## Stellaris<sup>®</sup> LM3S1811 RevB1 Errata

This document contains known errata at the time of publication for the Stellaris<sup>®</sup> LM3S1811 microcontroller. The table below summarizes the errata and lists the affected revisions. See the data sheet for more details.

Figure 1. Workaround Circuit to Ensure Initial Power Up

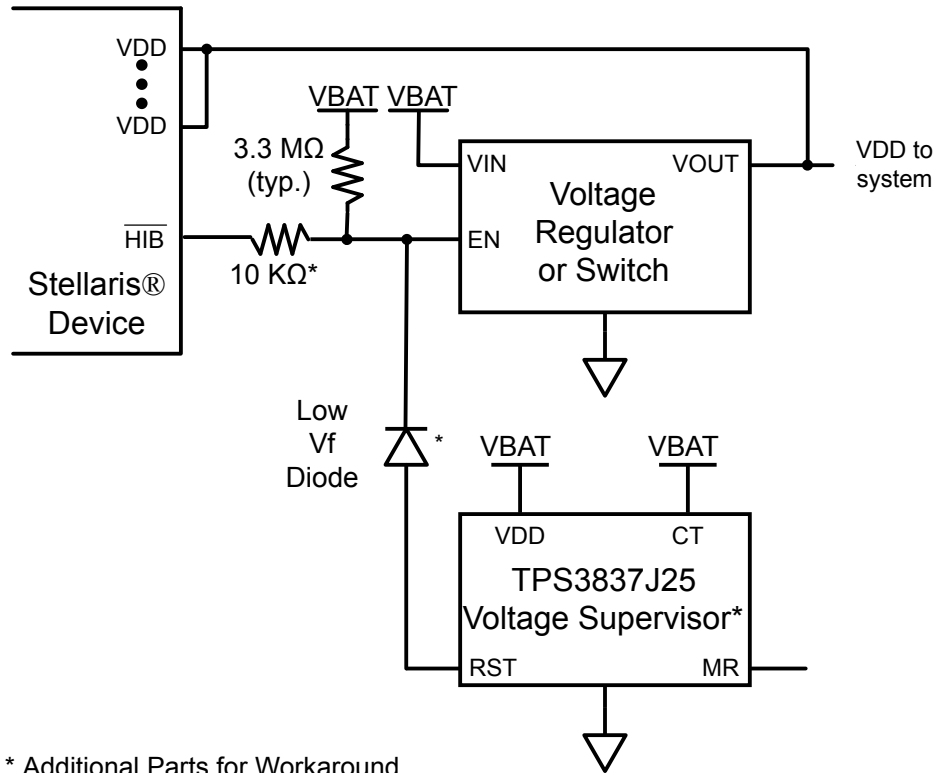
If V<sub>DD</sub> is not powered when voltage is first applied to V<sub>BAT</sub>, the state of the Hibernation module is indeterminate and the  $\overline{\text{HIB}}$  signal may be asserted. In this indeterminate state, a lock condition can occur in which the Hibernation module waits for a power-on-reset, but that reset cannot occur until the module deasserts  $\overline{\text{HIB}}$ . This issue is related to the errata "Hibernation module may have higher current draw than specified in data sheet under certain conditions" on page 4.

The workaround implementation depends on the system-level power supply configuration. For systems that use a battery as the primary power source, an external voltage supervisor (TPS383J25DBV or similar) circuit can be added to force the V<sub>DD</sub> power supply to start when the battery voltage is first applied (see Figure 1). The voltage supervisor requires only 220 nA and generates a 200-ms positive pulse to turn on the V<sub>DD</sub> regulator and activate the microcontroller's internal POR circuit.

**Figure 2. Configuration of External Regulator**

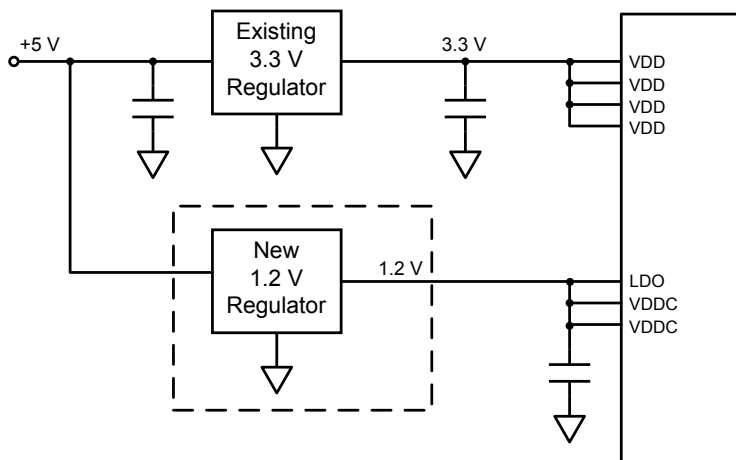
Incorrect power sequencing during power up can disrupt operation and potentially cause device failure.

$V_{DDC}$  must be applied approximately 50  $\mu$ s before  $V_{DD}$ . Normally  $V_{DDC}$  is controlled by the part's internal LDO voltage regulator. The workaround requires the addition of an external regulator (see Figure 2) to ensure that  $V_{DDC}$  sequencing requirements are met (see Figure 3). Recommended regulators include FAN1112SX (SOT223) and FAN2558S12X (SOT23-5).
